Pre-Purchase Inspection Report

| Aircraft Make: | Kitfox | Aircraft registration: | C-FXCE |
| Aircraft Model: | Outback 5 | Aircraft S/N | 98080160 |

| Engine Type: | Rotax 912 ULS | Engine TTSN | Analog Hobbs: 384.3 Digital Hobbs: 482.9 |

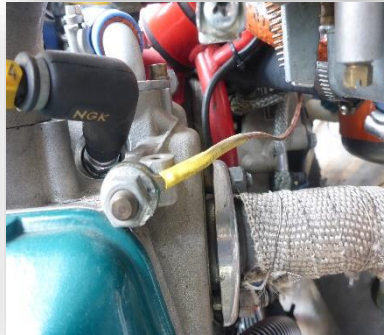
Lubrication System: The oil was found to be clean and in the middle of the flat portion of the dipstick (within limits). An aftermarket oil thermostat was incorporated into the oil system. The oil cooler was correctly installed and partially blocked with tape. Some operators who fly in colder climates often place tape over a portion of radiators to maintain operating temperatures. The inlet fitting of the oil cooler was not an optimal design or recommended due to its restrictive nature.

It's recommended to have the restrictive fitting changed to a more free-flowing type. The oil lines appeared to be in good overall condition with no leaks however, it's recommended to change the oil lines due to age.

Full flow oil fittings

- Only use full-flow fittings
- Do **not** use industrial/automotive fittings or Banjo bolts as they will restrict flow and cause turbulence.

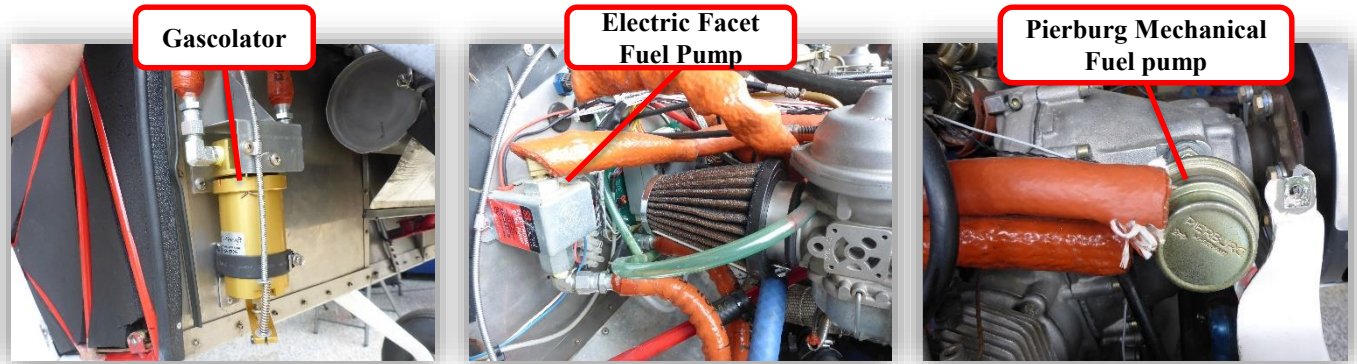
Fuel System: The fuel system was examined. Most of the fuel lines positioned forward of the firewall were covered in a protective fire sleeve and could not be fully examined. The portions of the fuel lines that were examined beyond the firewall were stiff and not pliable. When the fuel lines become hardened, they should be replaced.

Rotax sets a 5-year replacement limitation on all rubber components, including the mechanical fuel pump. The mechanical fuel pump installed on the engine was an "old Pierburg type" and well beyond 5 years old. The fuel system included a gascolator that appeared to be in good condition with easy access pull cable drain. A Facet electrical fuel pump was installed between the gascolator and the mechanical fuel pump. No anomalies were found with the electric fuel pump.

**Carburetor
intake sockets**

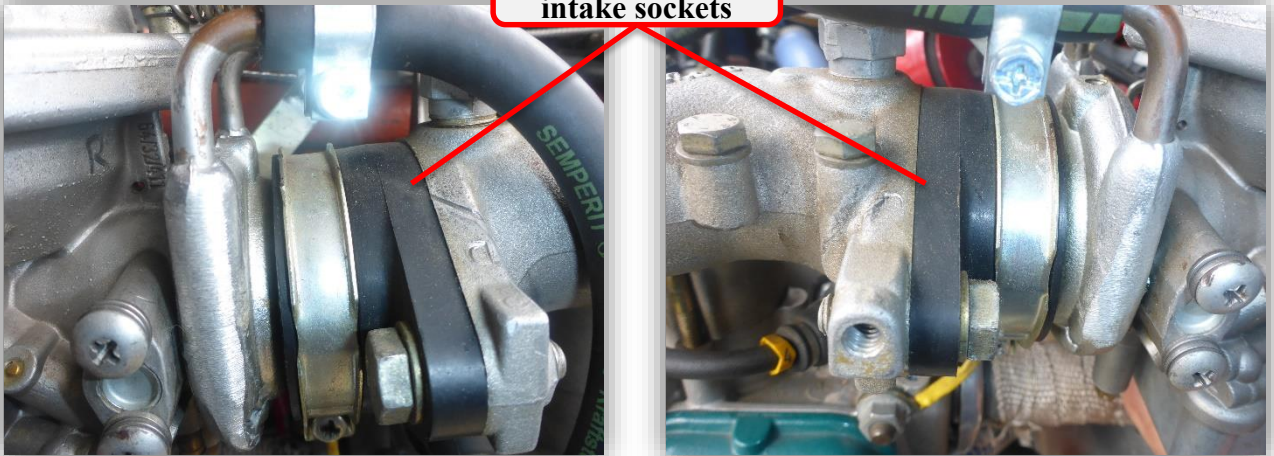
Carburetors (Continued): Both the 1/3 and 2/4 Carburetors intake sockets were examined for condition. It is unknown the age of the carburetor intake sockets however, they appeared to be in good overall condition with no evidence of cracking. The carburetor intake sockets have a life limit of 5 years as set out by Rotax and depending on when they were last changed, they may need to be replaced due to the age restriction. Due to the Kitfox engine mount design, the intake manifolds are swapped from one side to another for clearance. This places the carburetors further outboard than stock configuration and may cause more stress on the carburetor sockets. This can result in premature wear and issues when synchronizing the carburetors.

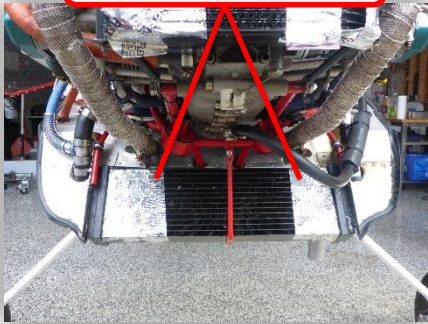
Coolant System: The coolant system was examined. The coolant radiator was correctly installed and partially blocked with tape (same as oil cooler) no anomalies were found with the coolant radiator. Some of the coolant lines were slightly swollen and should be replaced. The coolant lines that run from the cylinder heads to the water pump were upgraded to silicone and do not fall under the 5-year rubber replacement as set out by Rotax. All silicone lines appeared to be in good overall condition with no evidence of leakage.

A small amount of coolant was found on the base of the water pump, however, it could not be determined if the water pump was leaking as there was no evidence of coolant on the bottom of the engine cowling. This coolant could have come from the service of the coolant system. The coolant expansion tank was full of what appeared to be the correct type of coolant and the overflow bottle was mounted correctly.

Slight coolant drip on bottom of water pump

Swollen Coolant line

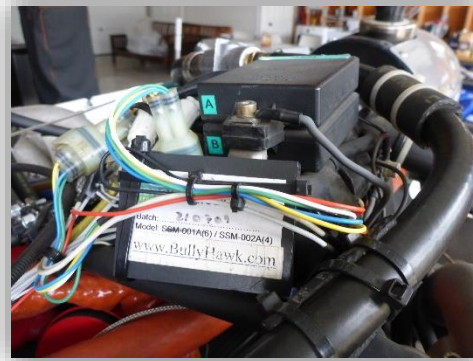
Ignition System: An aftermarket “Bully Hawk” soft start ignition module was installed on the engine. Some cracking of the protective shielding was seen on the ignition modules. This type of cracking is fairly superficial and may not affect the overall performance of the ignition system.
